December 10, 1997

## NOTICE OF DISCREPANCIES ON THE PASS A-40 AMPLIFIER PCB

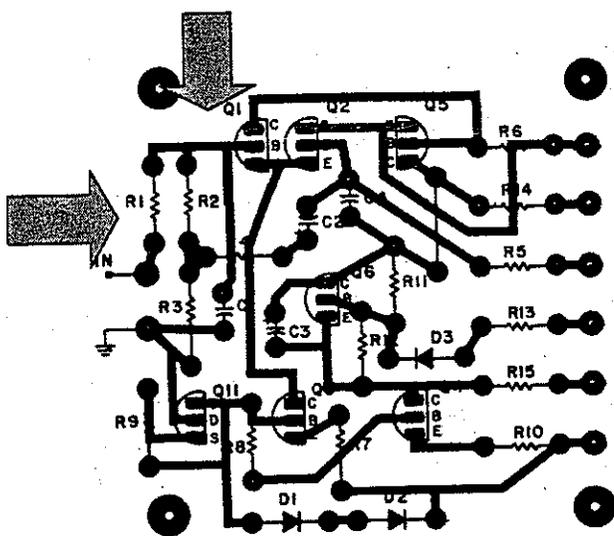
The printed circuit board called PASS A-40 has been found with a trace error on the base of Q1. The following graphics depict the differences between the board as it should have been reproduced and the way in which it actually was made. By cutting ONE trace and soldering a single jumper wire, the problem can be resolved.  
Thank you.

Depicts the way the board is upon receipt

Depicts the board after corrections
